Project Name:	Coldharbour Farm Road, Emsworth
Document Reference:	187.0018/TN/1
Document Name:	Transport Note
Prepared By:	Mark Smith (May 2026)
Checked By:	Mark Smith (May 2026)
Approved By:	Mark Smith (May 2026)

TECHNICAL RESPONSE TO HCC HIGHWAYS COMMENTS

Road Safety Audit Report

Proposed Continuation of Coldharbour Farm Road Emsworth

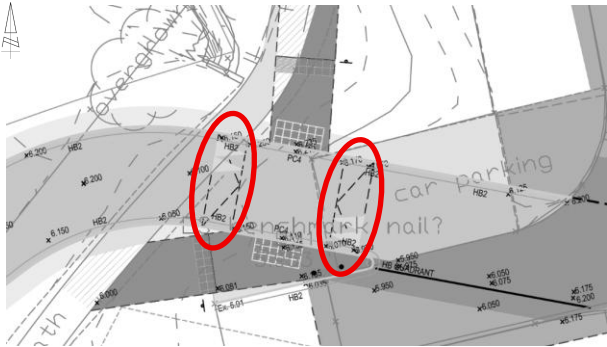
RECOMMENDATION:	
It is recommended that the carriageway is adequate for cars and LGVs to pass one another.	
Location Plan:  	
B.2	GENERAL
B.2.1	PROBLEM
Location:	Proposed continuation
Summary:	No details of the proposed raised table have been provided
Acc Type:	Vehicle to non-motorised user, sideswipe type collisions
<p>The proposals include the provision of an uncontrolled crossing over the proposed access road that is to be situated on a raised table. Whilst the provision of a raised table should ensure that motorists reduce their speed on approach, no details of the associated ramps have been provided. The Audit Team have concerns that the proposed raised table will be too shallow which will not</p>

achieve the desired speed reduction which could lead to a vehicle to non-motorised user as well as sideswipe type collisions.

It is recommended that the proposed raised table includes adequate ramps that force traffic slow.

The raised table ramp length has been designed in accordance with HCC detail HCC11/C/105 Rev B.

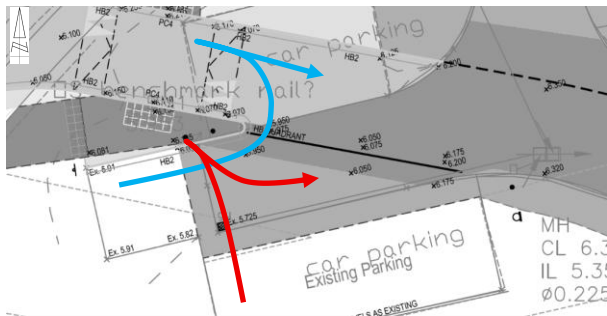
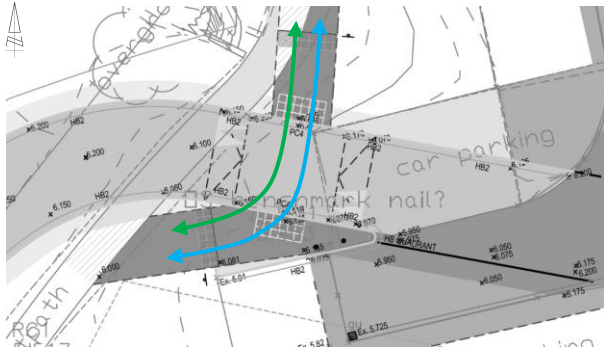
Summary: Vehicles may not be able to access the existing parking bays.

The proposals include the continuation of Coldharbour Farm Road where a number of parking bays are provided both sides of the carriageway. The existing parking cul-de-sac off the northern side is to remain largely unchanged with a 6.0 metre aisle that allows for easy access to each bay and an edge of carriageway marking provided which will highlight priorities. It is noted, however, that the parking bays to the south of Coldharbour Farm Road do not benefit from an aisle that is of adequate width to allow a car to turn (6 metres). Motorists wishing to access the existing bays, will therefore be required to reverse off or onto the Coldharbour Farm Road carriageway. Speeds will be low and therefore motorists should become aware of one another and proceed accordingly. The Audit Team have concerns, however, that a vehicle will be required to encroach the proposed uncontrolled crossing or shared footway cycleway when manoeuvring into / out of the existing spaces which could lead to vehicle to non-motorised user type collisions.

It is recommended that the bays are accessible.

The existing parking bays are proposed to be relined as shown on Drawing 23339-JUBB-XX-XX-DR-X-000100 REV C13 and the tracking is shown on Drawing 23339-JUBB-XX-XX-DR-X-001203 REV C1.

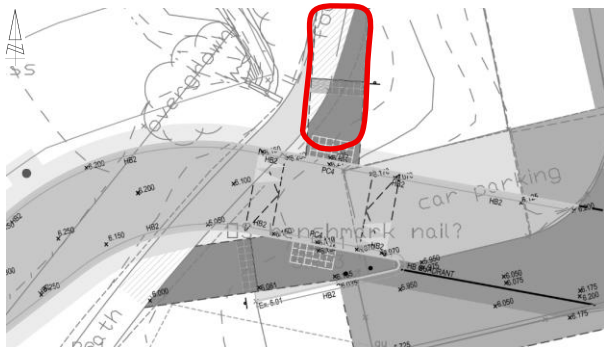
RECOMMENDATION:	
It is recommended that an appropriate level of visibility is achievable.	
<p>Location Plan:</p>  	
B.4.2	PROBLEM
Location:	Coldharbour Farm Road
Summary:	Non-motorised users at and on approach to the uncontrolled crossing may not be clearly visible during the hours of darkness
Acc Type:	Vehicle to pedestrian type collisions
<p>The public footpath 108/71/1 that is present to the west of the Coldharbour Farm Road cul-de-sac provides a link between the facilities available at Emsworth Park and the residential areas to the south. During the site visits associated with this scheme, numerous pedestrians to include joggers and cyclists have been observed. The proposals include the continuation of Coldharbour Farm</p>

<p>Road to the west severing the existing footpath. As part of the proposals, an uncontrolled crossing is to be provided on a raised table. This crossing is to benefit from tactile paving to a depth of 1200mm which should be sufficient to warn all pedestrians of the live carriageway. The scheme drawing illustrates that visibility splays of 2.4x43 metres are achievable from the uncontrolled crossing, however, they do not extend to the tangent and it is noted that the footpath is not illuminated. The Audit Team have concerns that visibility of a non-motorised users immediately approaching the proposed uncontrolled crossing is limited, particularly during the hours of darkness which could lead to a vehicle to pedestrian type collision.</p>

<p>RECOMMENDATION:</p>	
<p>It is recommended that visibility is achievable to the tangent and that the proposed crossing point is illuminated adequately with a column provided immediately to the west of the crossing point as previously proposed.</p>	
<p>Location Plan:</p> <div></div>	
<p>B.5</p>	<p>TRAFFIC SIGNS, CARRIAGEWAY MARKINGS AND LIGHTING</p>
	<p><i>No Road Safety Concerns regarding TRAFFIC SIGNS, CARRIAGEWAY MARKINGS AND LIGHTING have been raised at this stage</i></p>

Suitable visibility splays for cyclists are as shown on Drawing 23339-JUBB-XX-XX-DR-X-000100 REV C13. In dashed orange. With regards to lighting, this has been confirmed as suitable by the lighting designer.

Suitable visibility splays for pedestrians are as shown on Drawing 23339-JUBB-XX-XX-DR-X-000100 REV C13. In dashed yellow. With regards to lighting, this has been confirmed as suitable by the lighting designer.

DRAWING NO: JUBB_XX_XX_DR_C_100

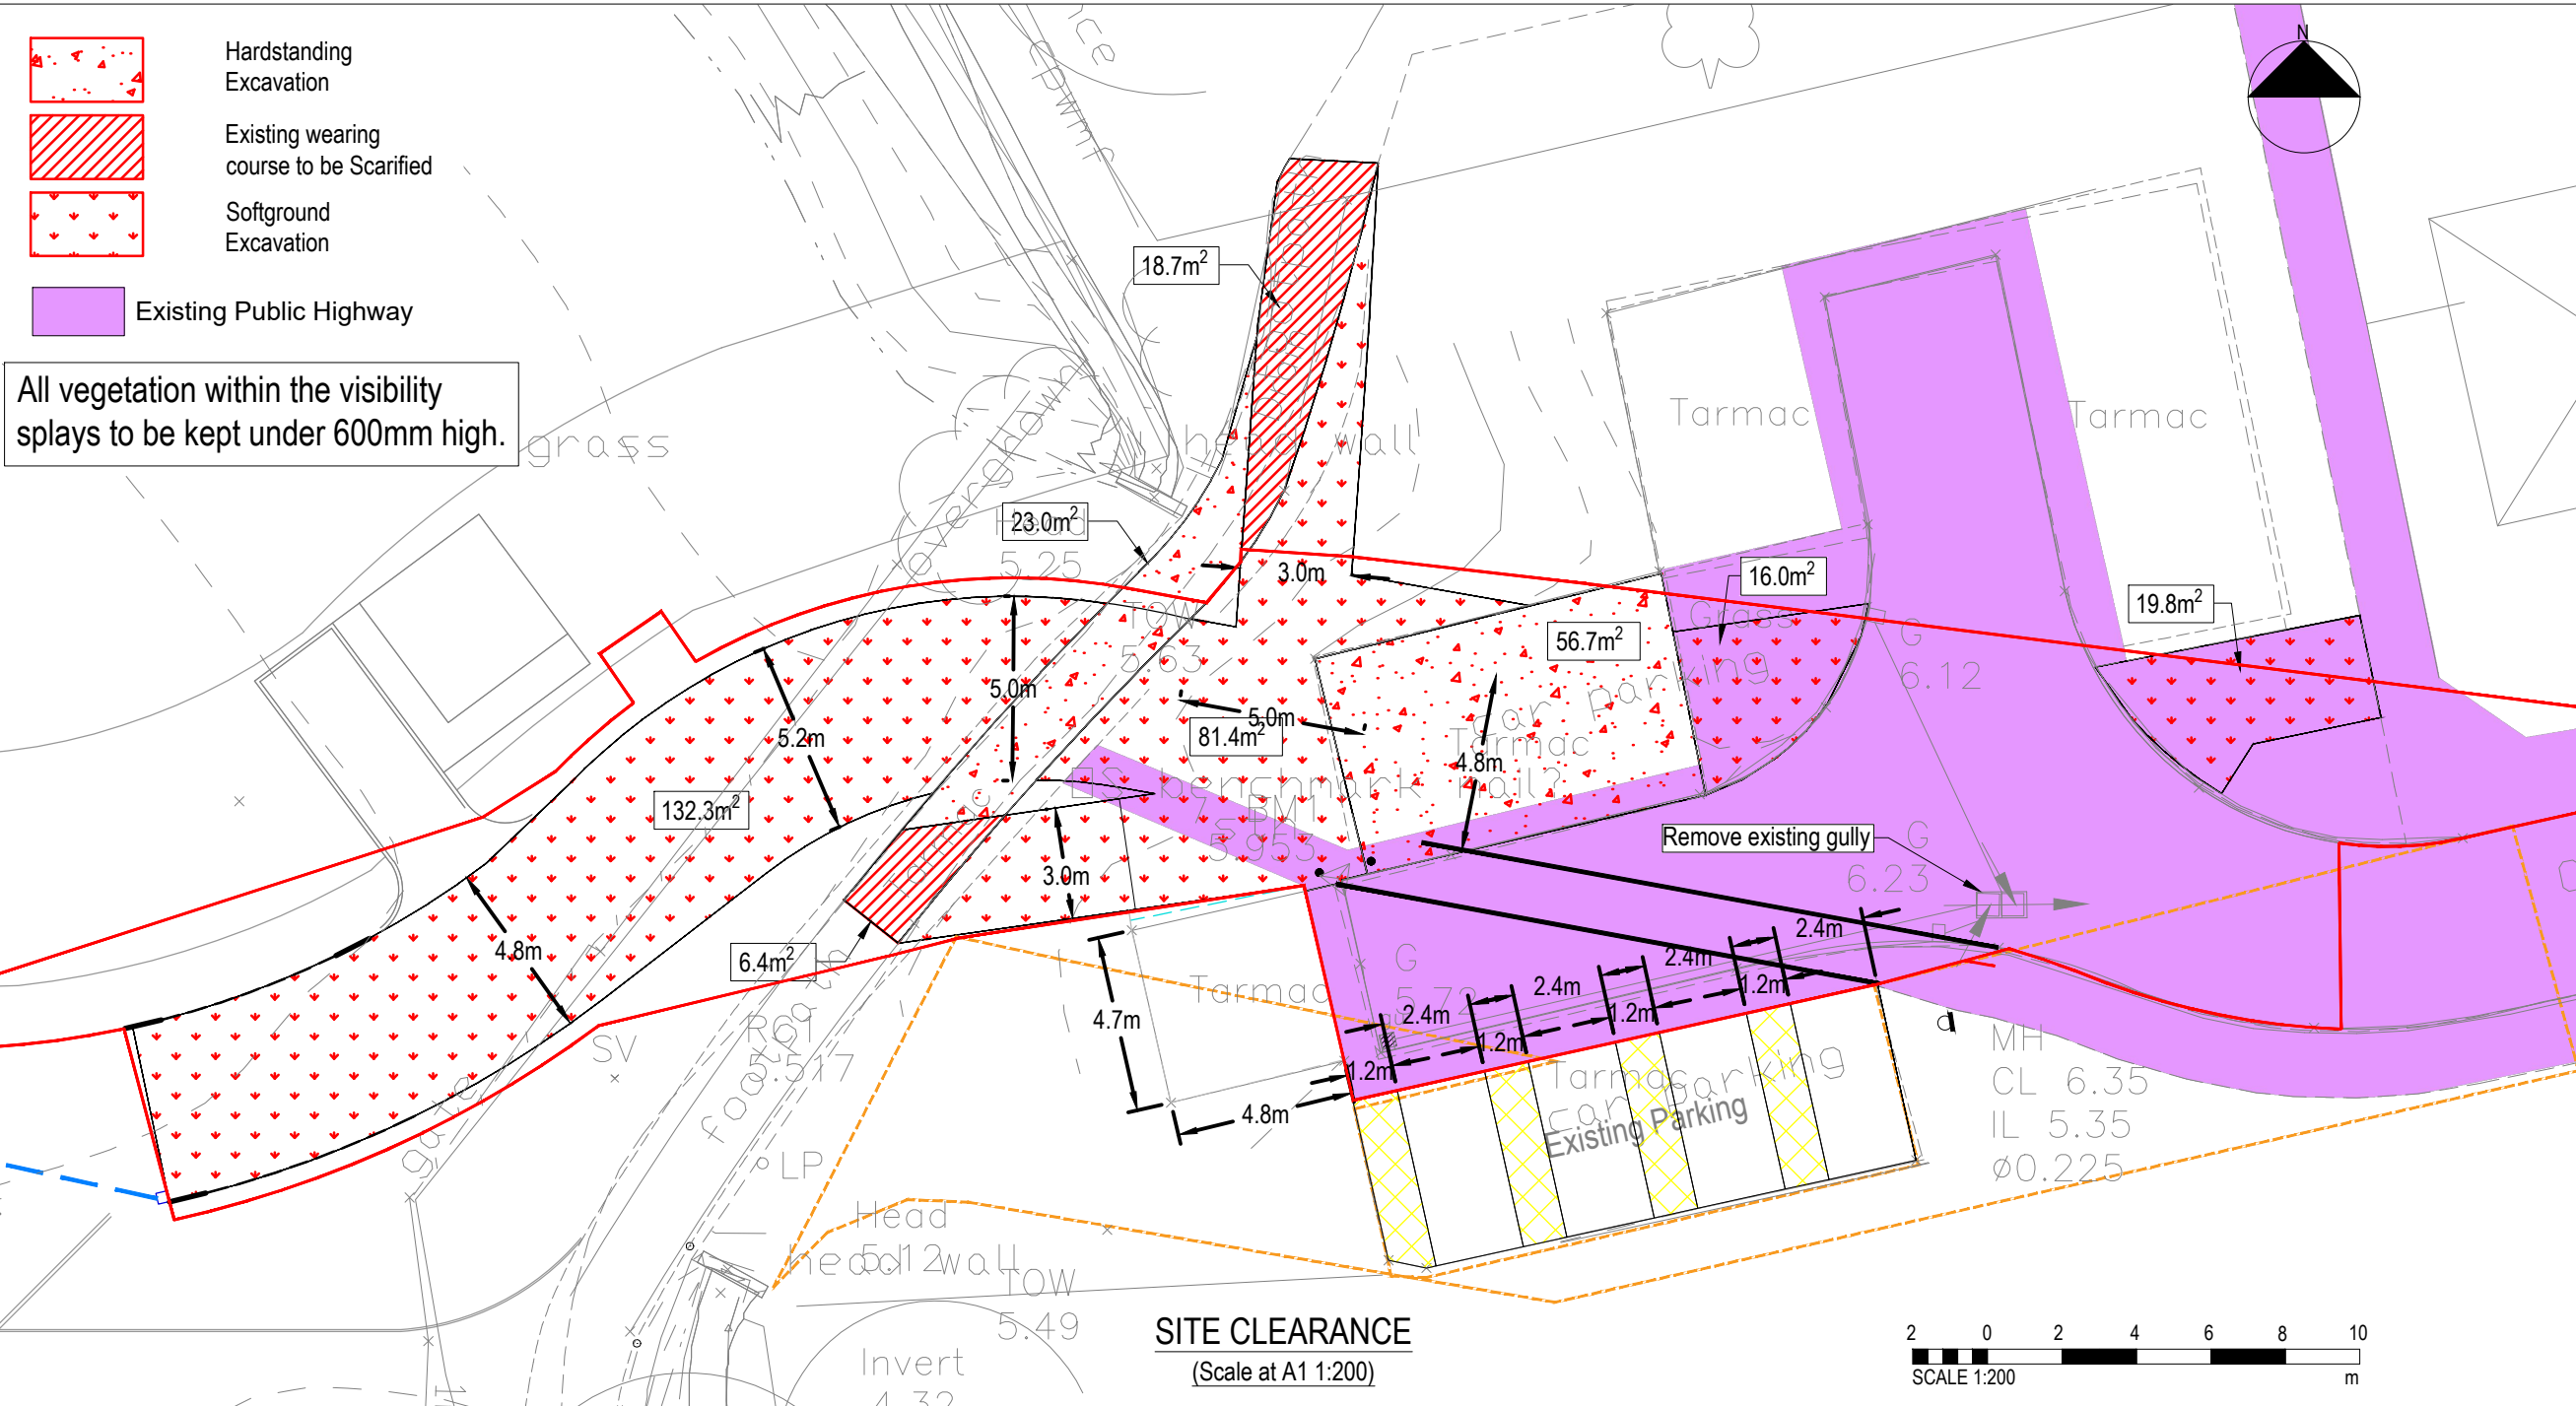
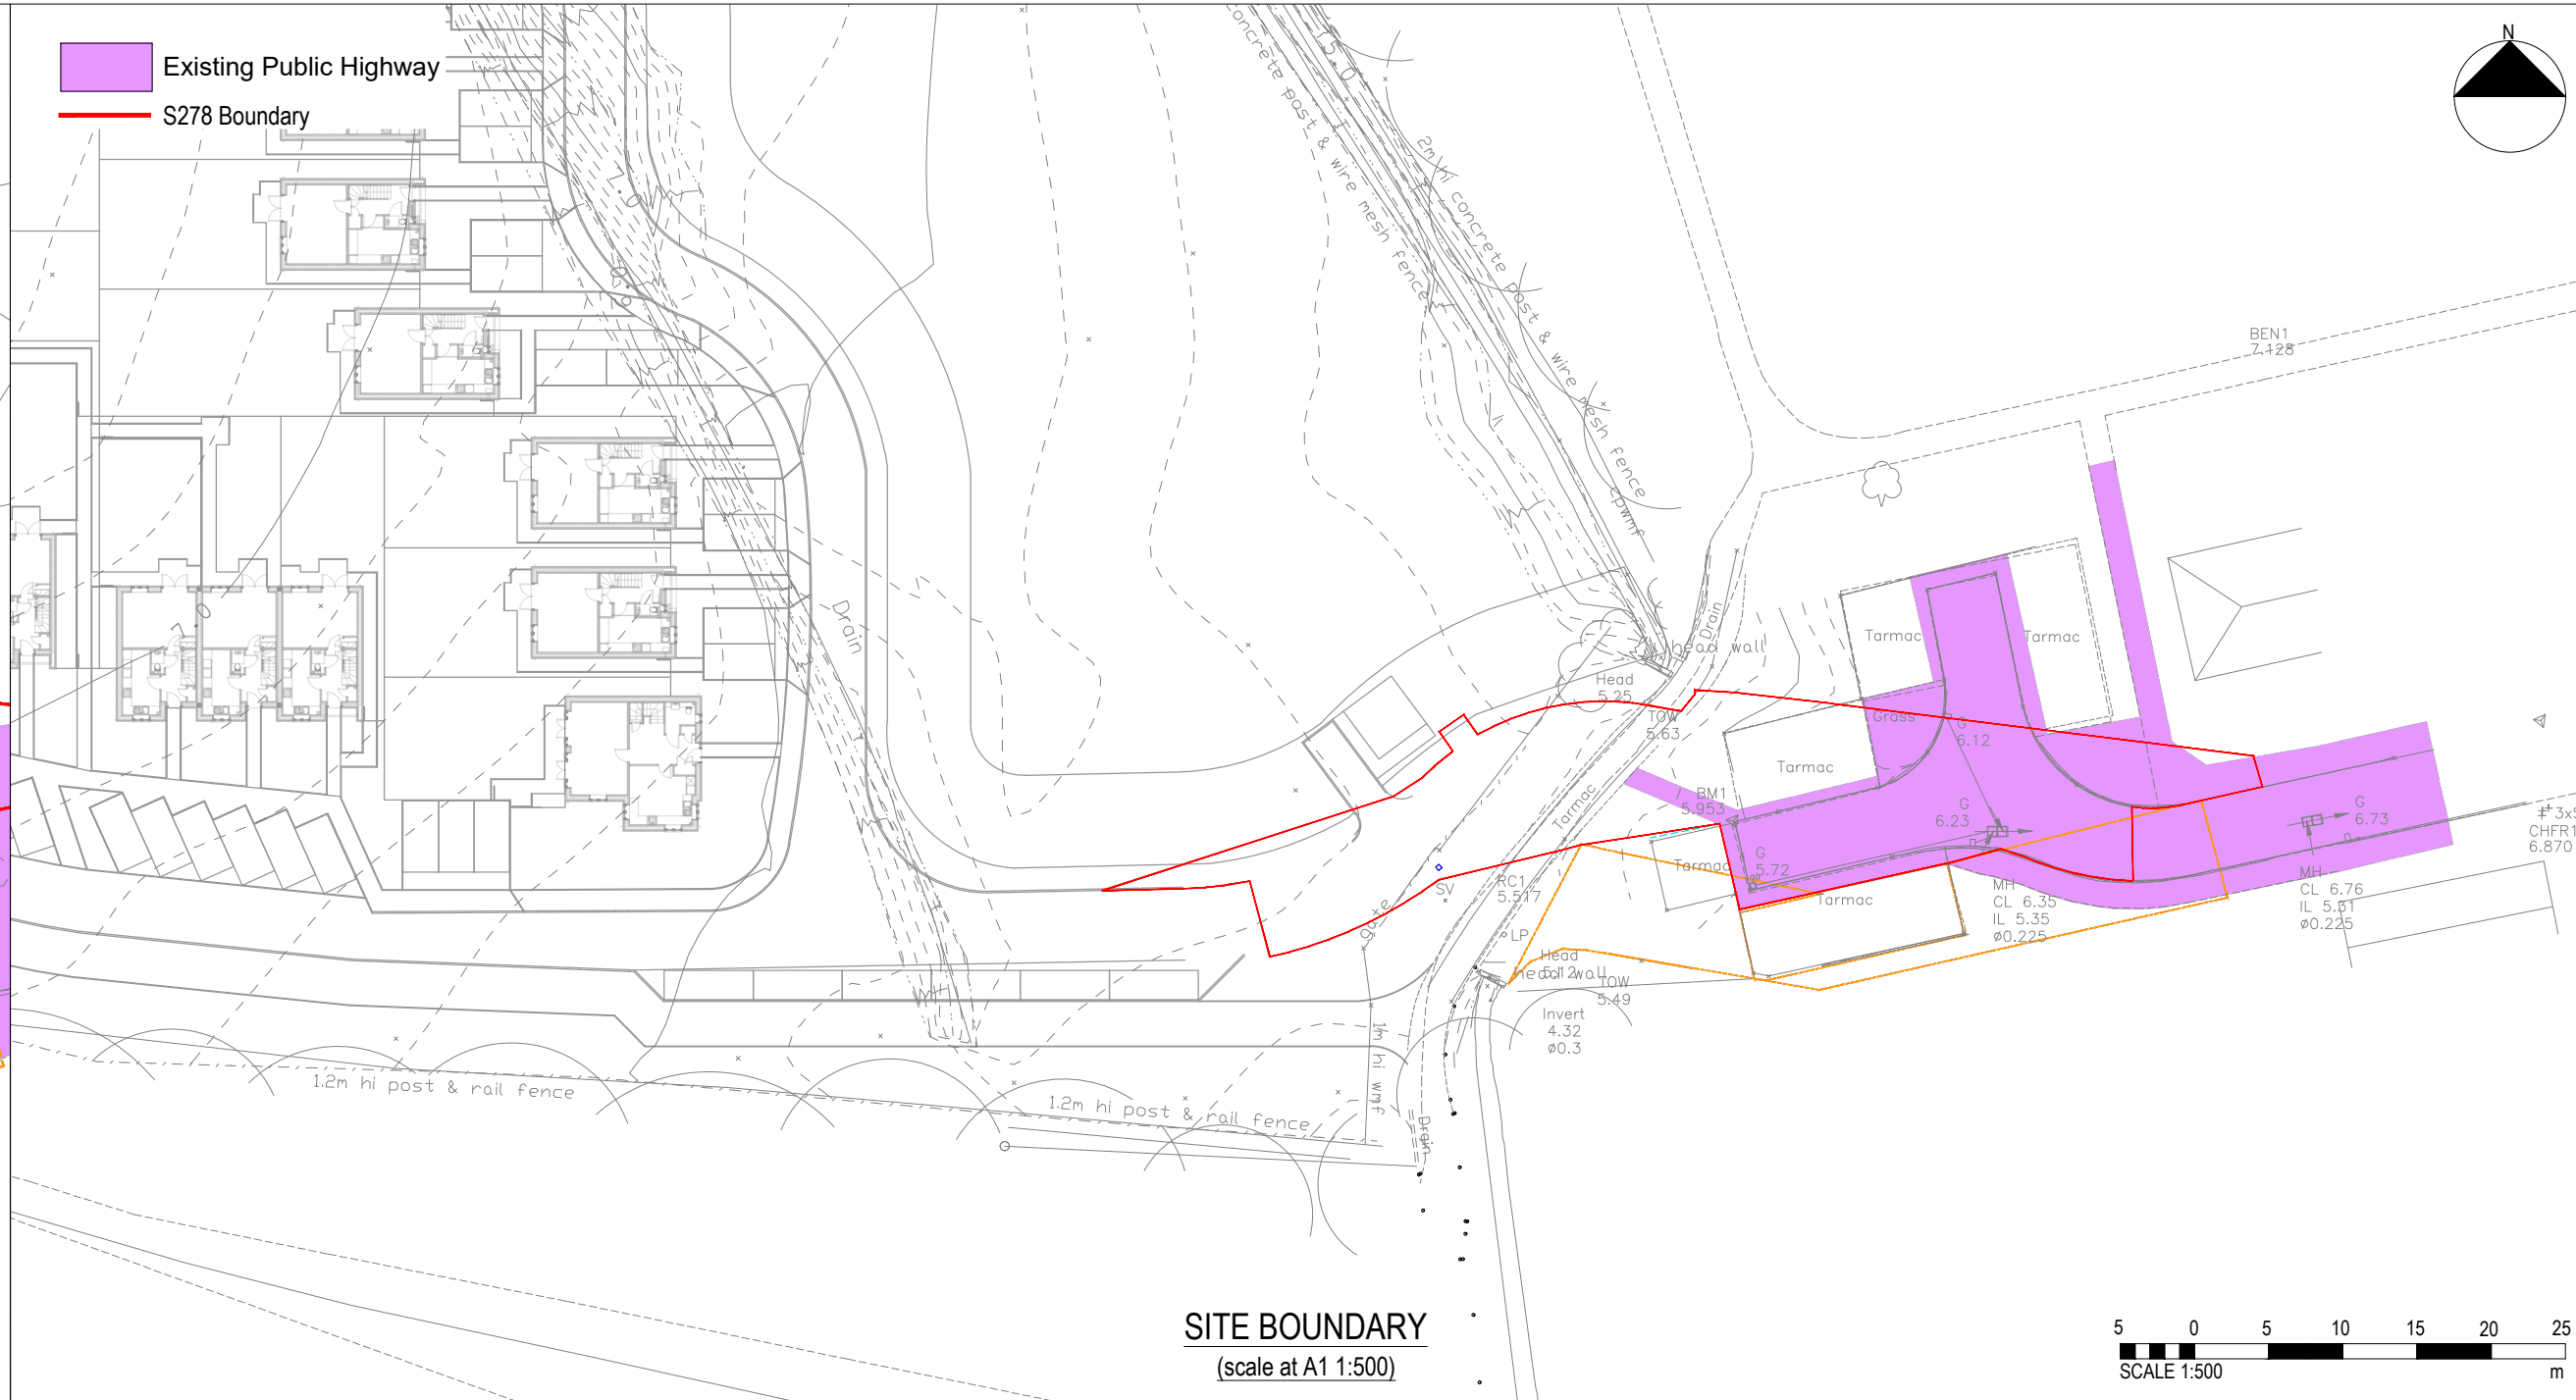
B2.2 Vehicles may not be able to access the existing parking bays. It is recommended that the bays are accessible.

B.4.1 - Cyclists are likely to continue without giving way to traffic. It is recommended that an appropriate level of visibility is achievable.

B.4.2 - Non-motorised users at and on approach to the uncontrolled crossing may not be clearly visible during the hours of darkness. It is recommended that visibility is achievable to the tangent and that the proposed crossing point is illuminated adequately with a column provided immediately to the west of the crossing point as previously proposed.
